SERVICE BULLETIN

N° 139-695

ATA 56 - INSTALLATION OF ACRYLIC WINDSHIELDS

This Service Bulletin is issued in order to provide the necessary instructions on how to perform the installation of the kit acrylic windshields P/N 3G5610F00211.

Figure 1

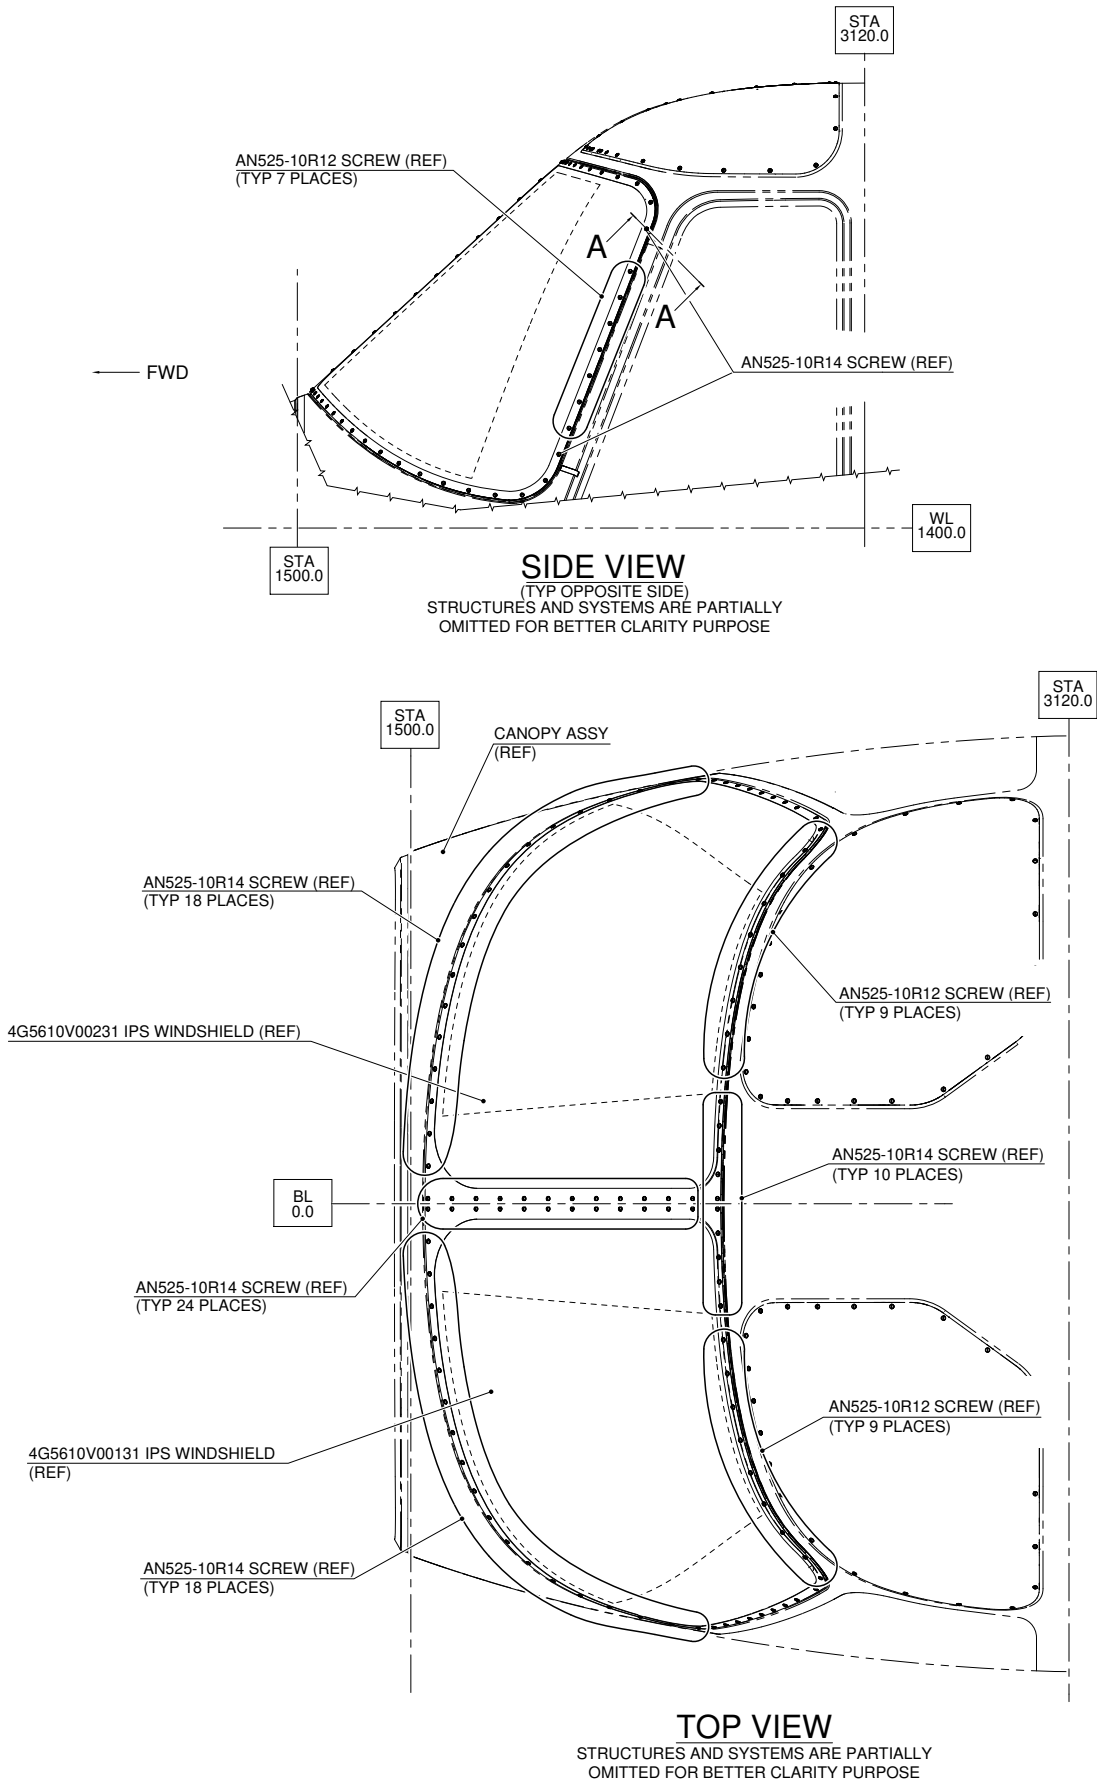
3. In accordance with AMP DM 39-A-30-72-01-00A-520A-K and with reference to Figure 1, remove the left windshield P/N 4G5610V00131 and the related hardware. Retain washers for later re-use.

4. With reference to Figure 3, protect the sectioning connector J175 by means of the plug P/N NAS813-20.
5. In accordance with AMP DM 39-A-30-72-02-00A-520A-K and with reference to Figure 1, remove the right windshield P/N 4G5610V00231 and the related hardware. Retain washers for later re-use.

Figure 3

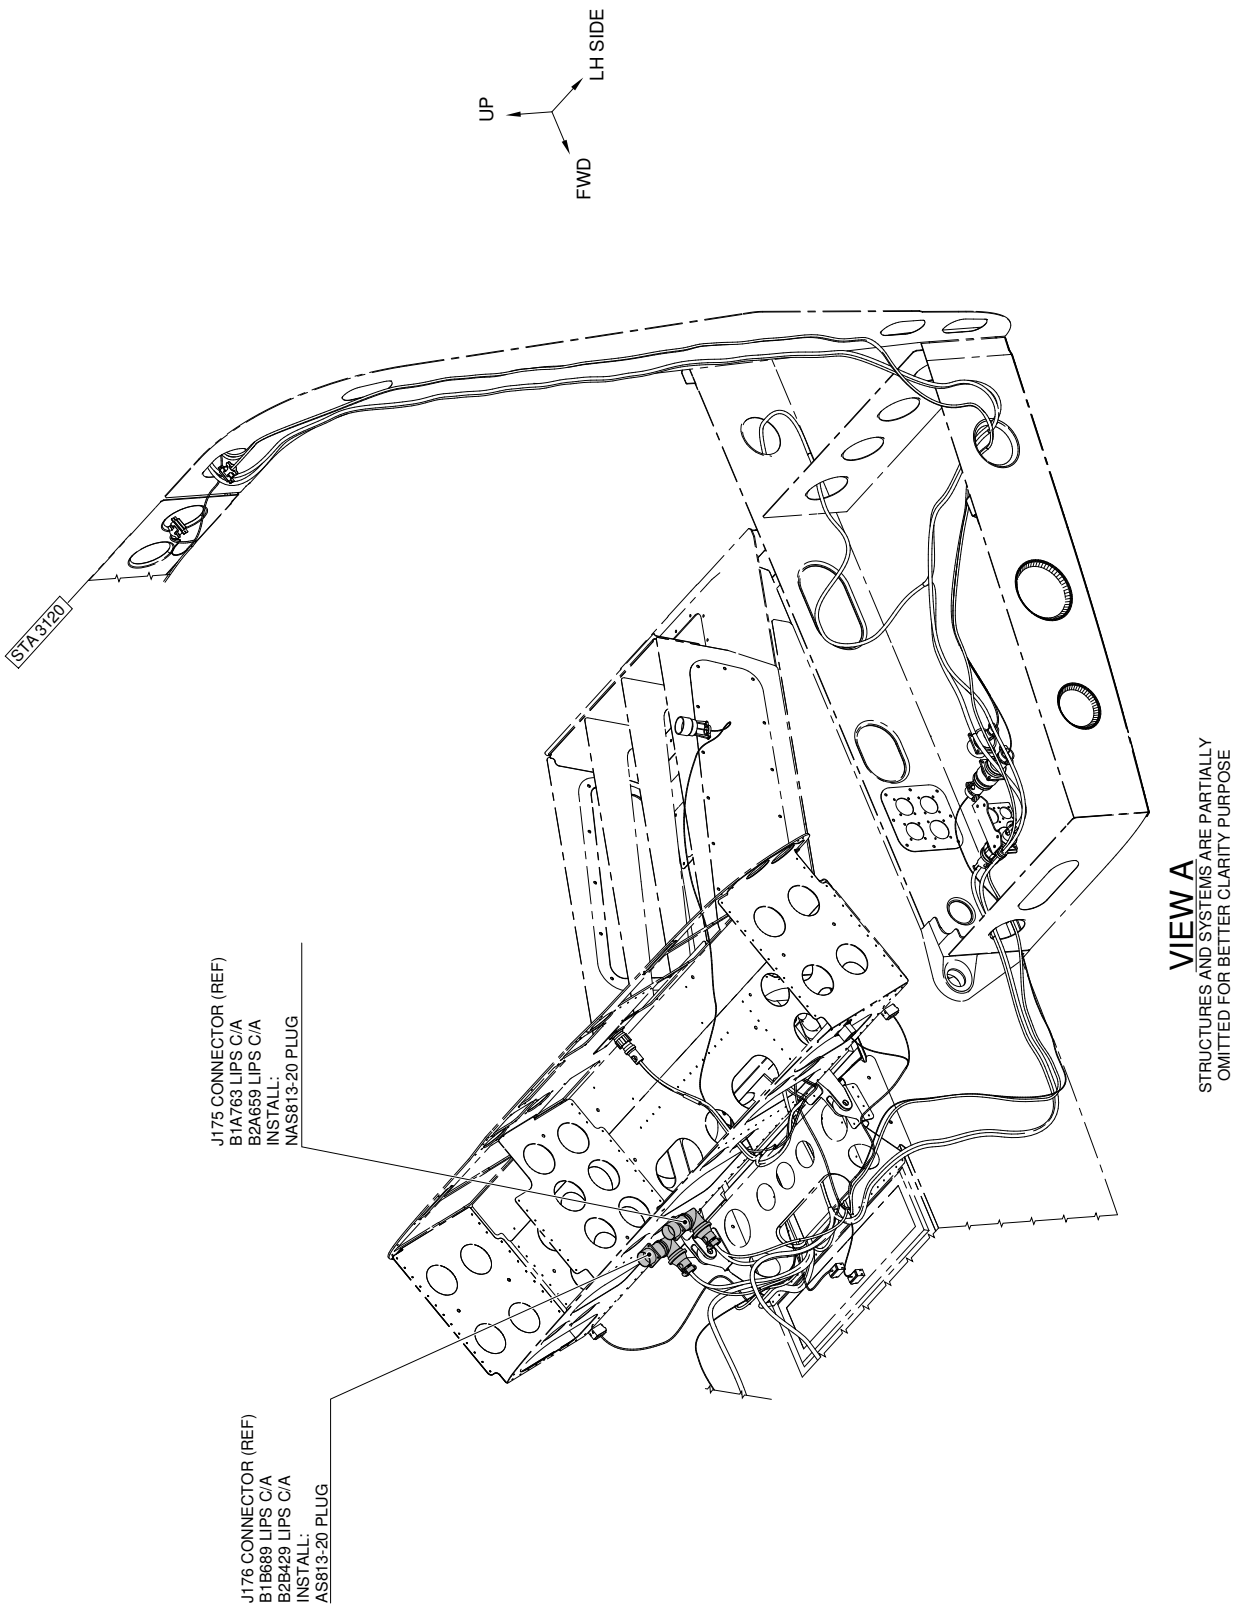
6. With reference to Figure 3, protect the sectioning connector J176 by means of the plug P/N NAS813-20.
7. With reference to Figure 4 View B and Detail D, disconnect connector A234P1 and protect by means of the plug P/N NAS813-20, the nomex P/N A582A40 or P/N EN6049-006-40-5 and the tape P/N 900004953.

Figure 5

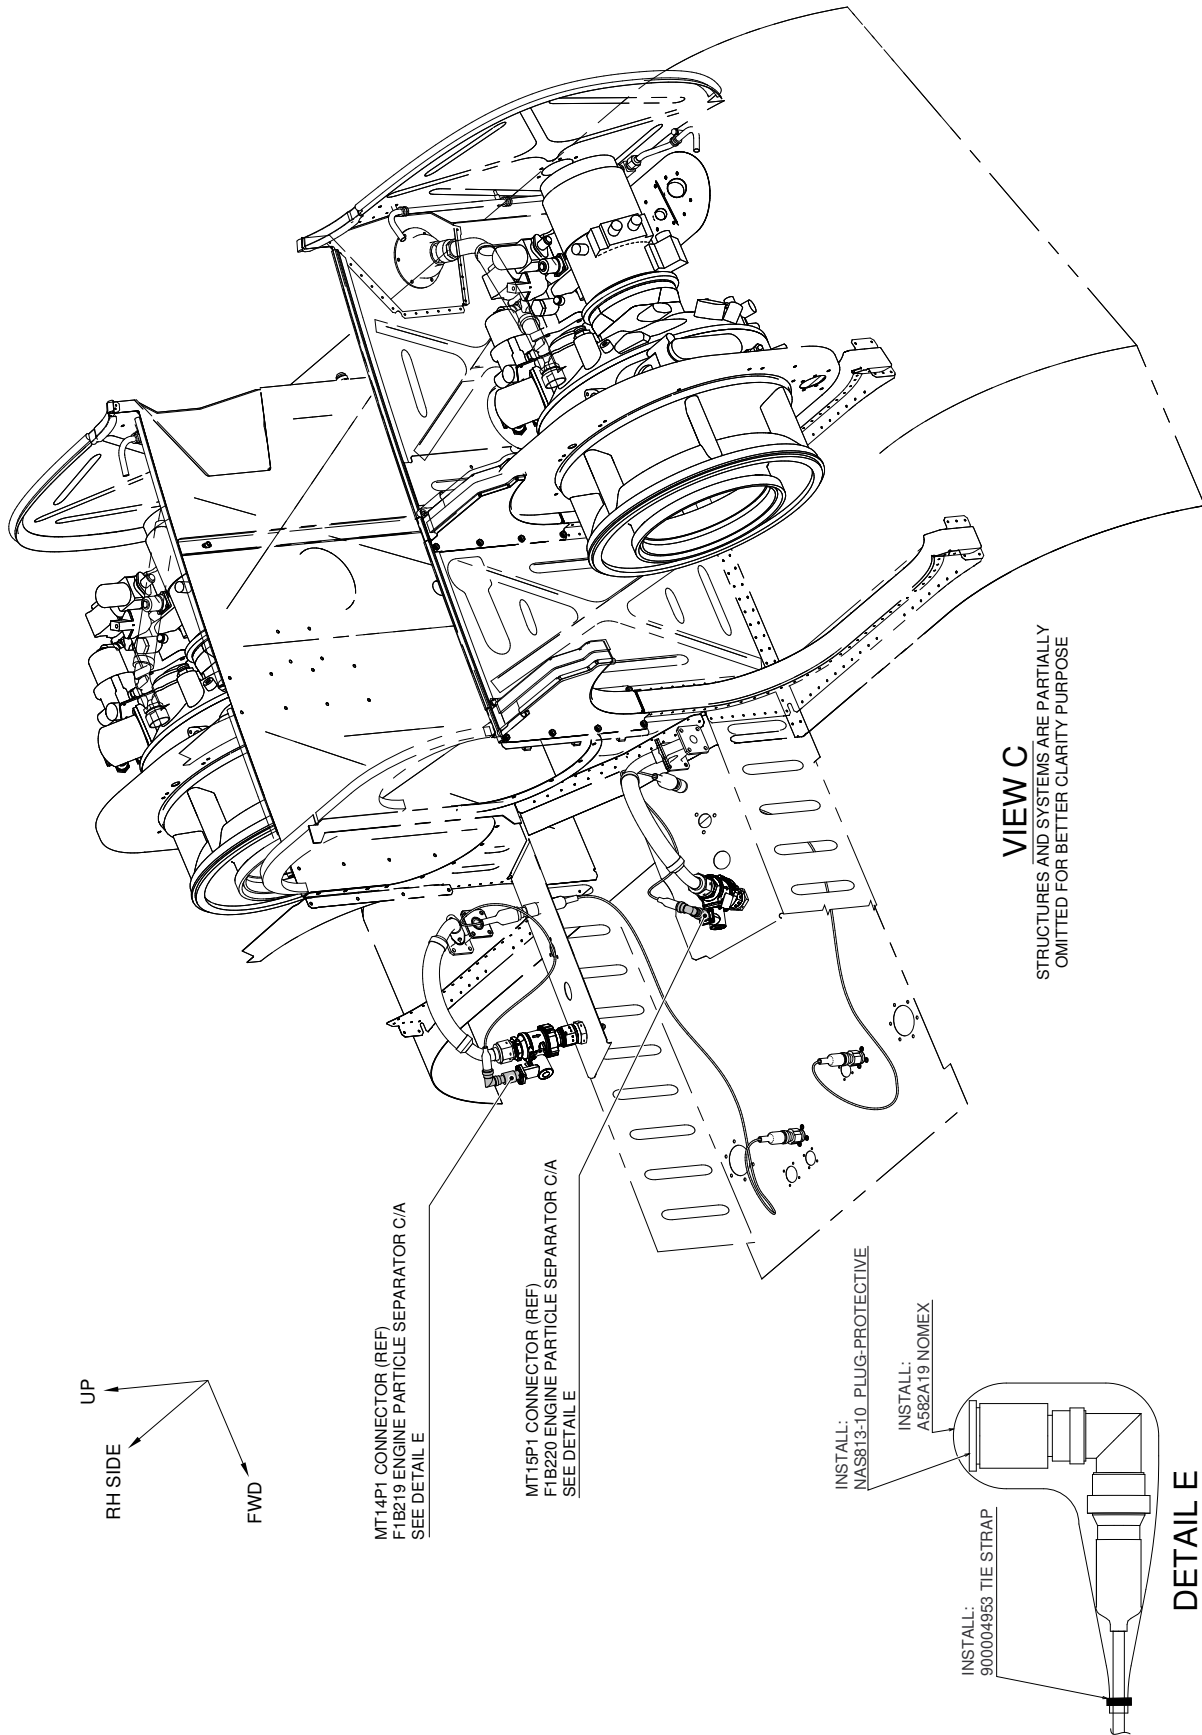
8. With reference to Figure 5 View C and Detail E, disconnect connector MT14 and protect by means of the plug P/N NAS813-10, the nomex P/N A582A19 or P/N EN6049-006-19-5 and the tape P/N 900004953.

9. With reference to Figure 5 View C and Detail E, disconnect connector MT15 and protect by means of the plug P/N NAS813-10, the nomex P/N A582A19 or P/N EN6049-006-19-5 and the tape P/N 900004953.

Figure 6

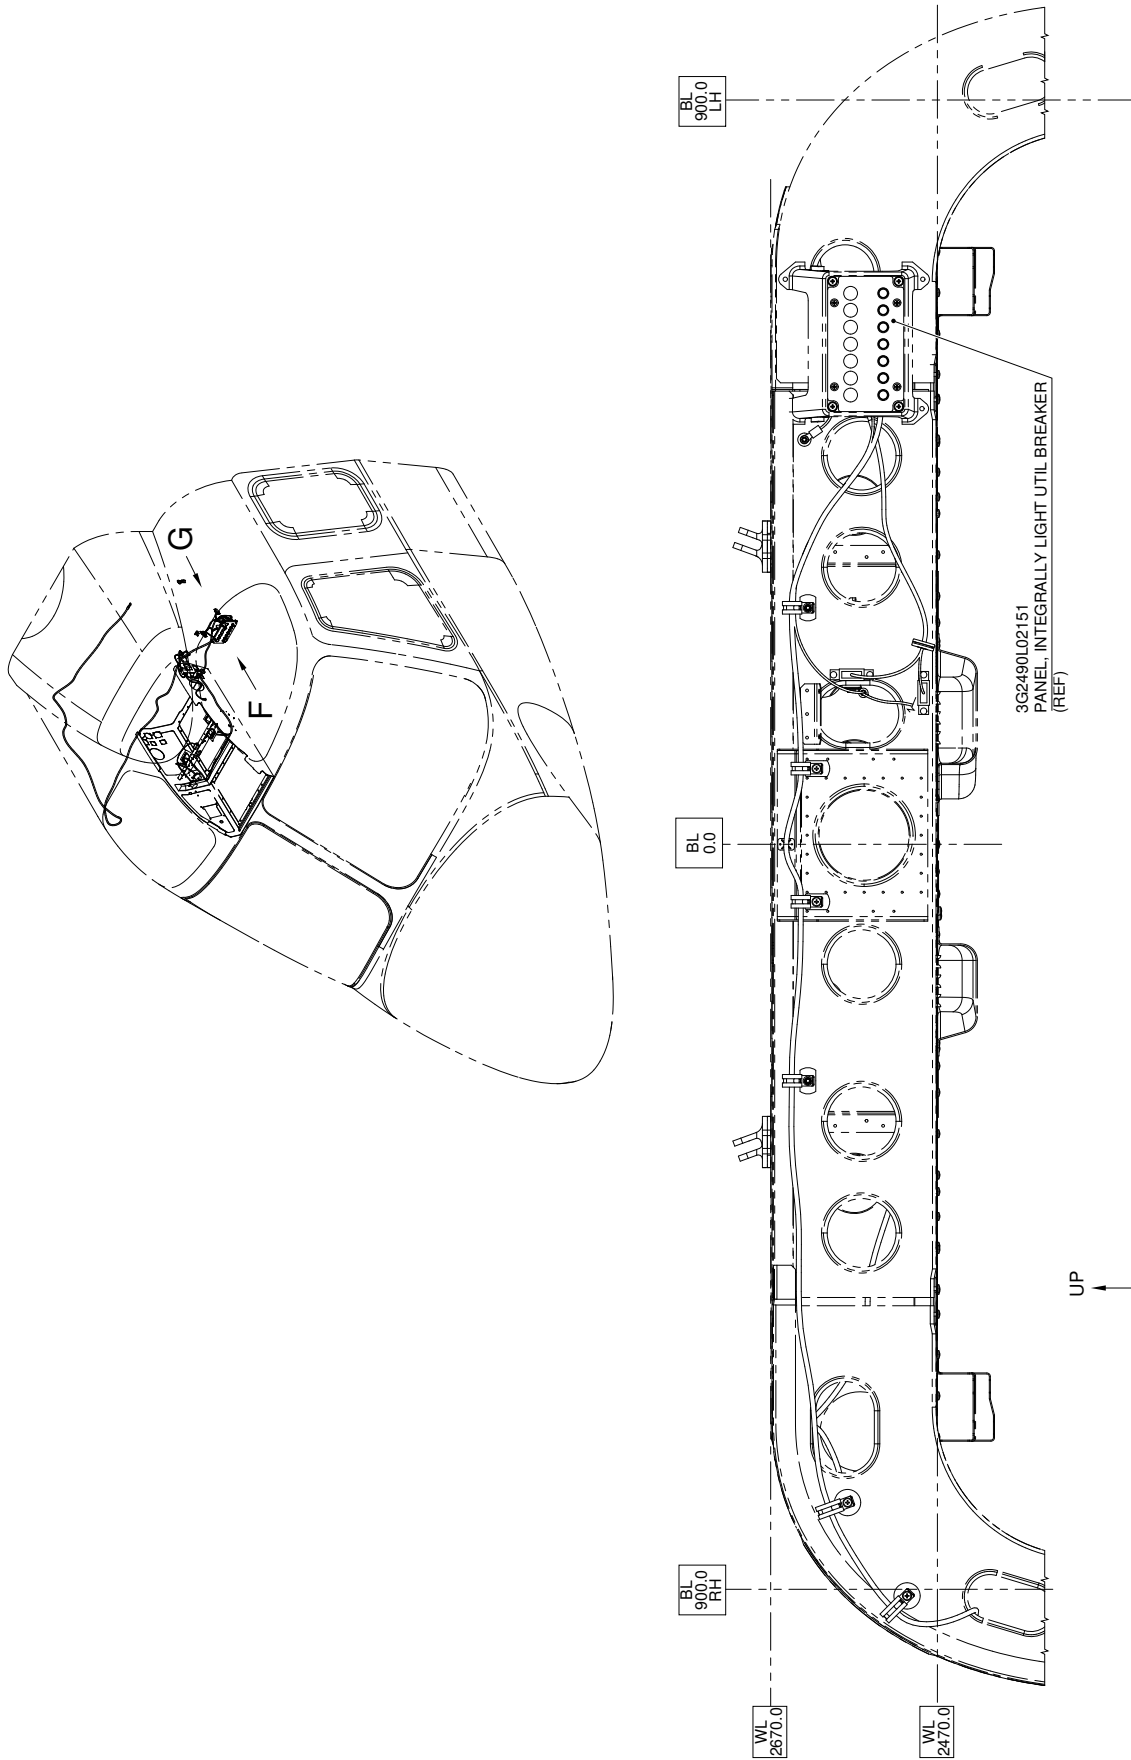
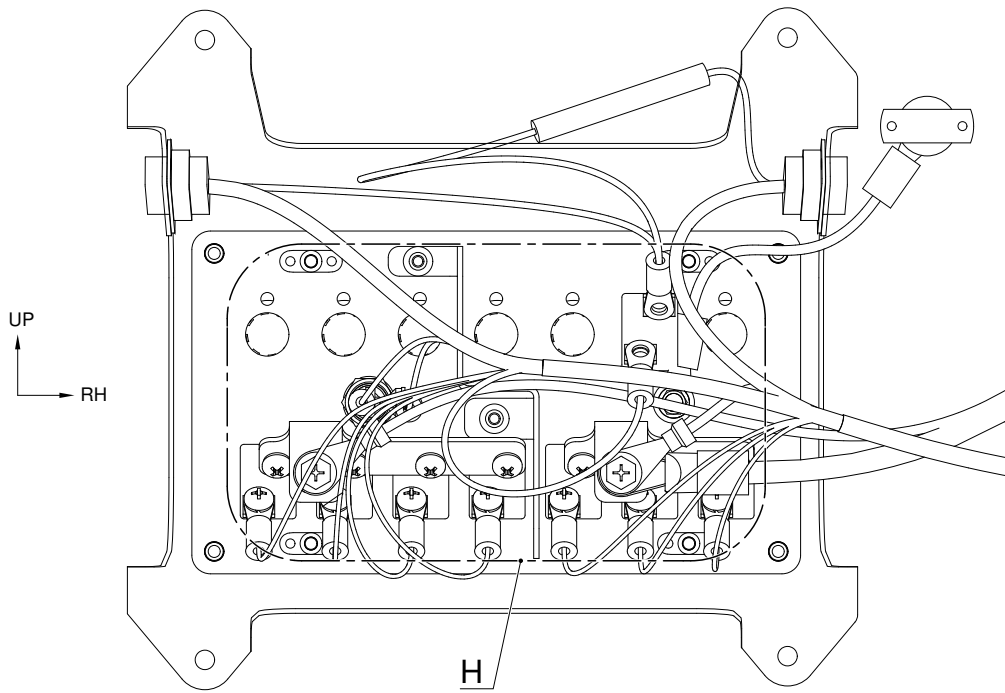
10. With reference to Figures 6 and 7, install n°7 lock rings P/N AW001YC01RED on the breaker of the integrally light util breaker panel P/N 3G2490L02151.

Figure 8

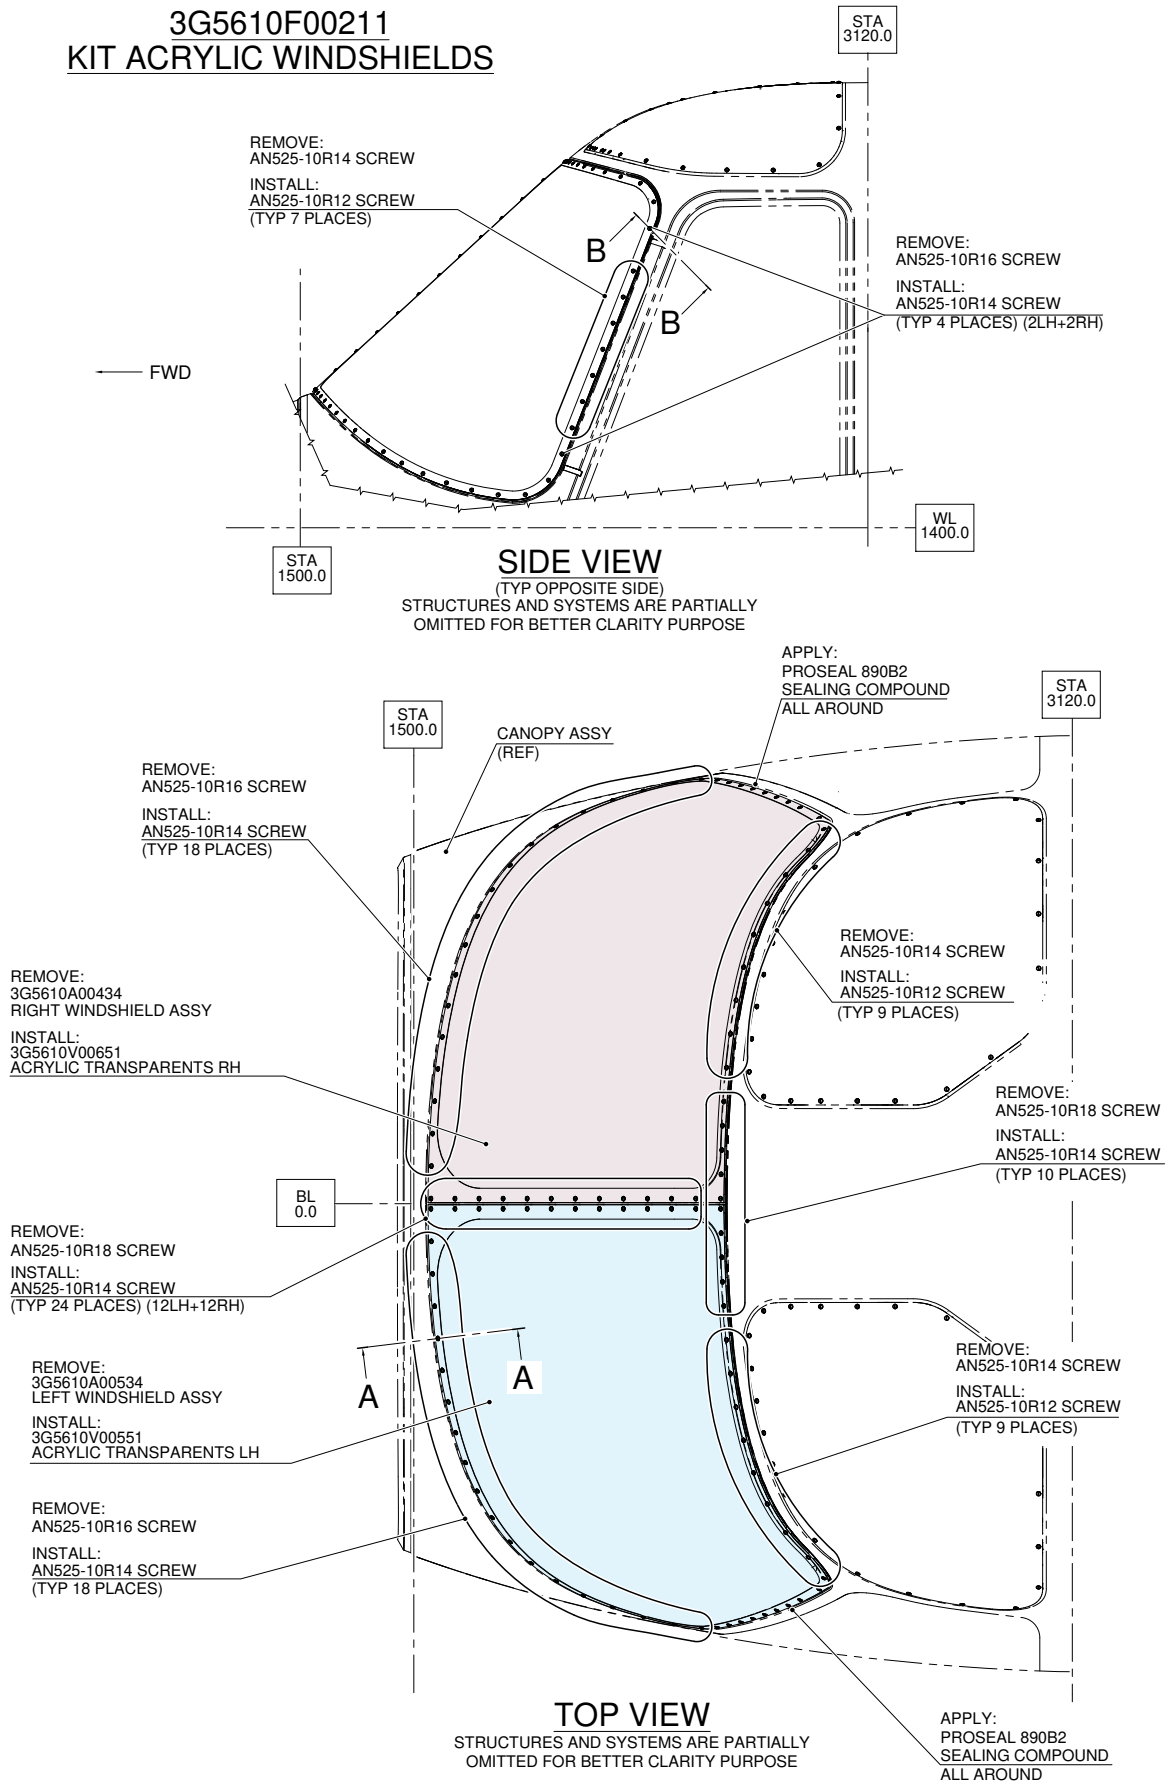
12. In accordance with AMP DM 39-A-56-11-01-00A-520A-A and with reference to Figure 8, remove the left windshield P/N 3G5610A00534 and the related hardware. Retain washers for later re-use.
13. In accordance with AMP DM 39-A-56-11-02-00A-520A-A and with reference to Figure 8, remove the right windshield P/N 3G5610A00434 and the related hardware. Retain washers for later re-use.

14. In accordance with AMP DM 39-C-56-13-01-00A-720A-K and with reference to Figures 8 thru 10, install the acrylic transparent LH P/N 3G5610V00551
15. In accordance with AMP DM 39-C-56-13-02-00A-720A-K and with reference to Figures 8 thru 10, install acrylic transparent RH P/N 3G5610V00651.
16. In accordance with AMP DM 39-A-06-41-00-00A-010A-A, re-install all external panels, internal panels and internal liners previously removed as required.
17. In accordance with weight and balance changes, update the Chart A (see Rotorcraft Flight Manual, Part II, section 6).
18. Return the helicopter to flight configuration and record for compliance with this Service Bulletin on the helicopter logbook.
19. Send the attached compliance form to the following mail box:
